NEC Code-Making Panel 2

Second Draft Meeting Agenda

November 9-14, 2015

Figure 210.52(C)(1) Determination of Area Behind a Range, or Counter-Mounted Cooking Unit or Sink.

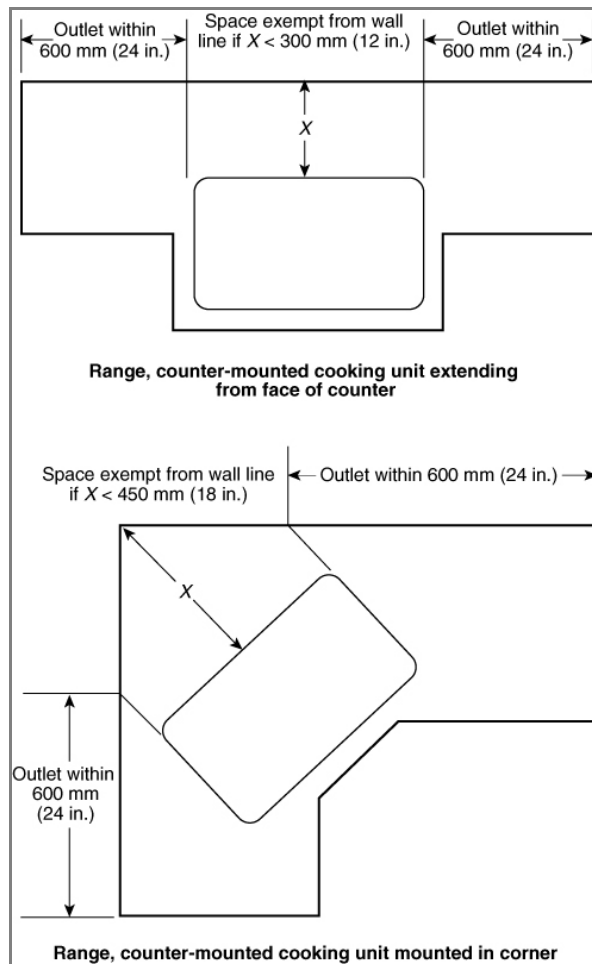
Public Comment No. 56-NFPA 70-2015 [Section No. 210.52(C)]
(C) Countertops and Work Surfaces .

Exception: Receptacle outlets shall not be required on a wall directly behind a range, counter-mounted cooking unit, or sink in the installation described in Figure 210.52(C)(1).
